Access Compliance Report

| Intersection ID: 2746 | Main Street: BELL'S_MILL_DR | Cross Street: TANAGER_LN | Location: E |
| ADA ID: BF561393E1E3 | Ramp Type: Perp | Initial Pass/Fail: Fail | Overall Compliance: No |

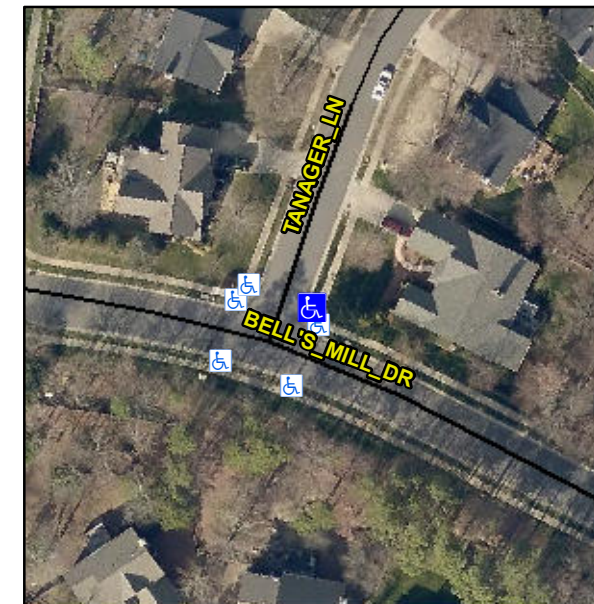
R304.5.1, R304.2.2, R304.5.3

| Compliance | Description | Data | Compliance | Description | Data |
|------------|-----------------------|-------|------------|-----------------------------|------|
| N/A | Ramp Length (in) | 48.0 | No | Ramp Slope (%) | 15.0 |
| No | Ramp Width (in) | 40.0 | No | Ramp XSlope (%) | 4.0 |

Remove & Replace Entire Ramp.
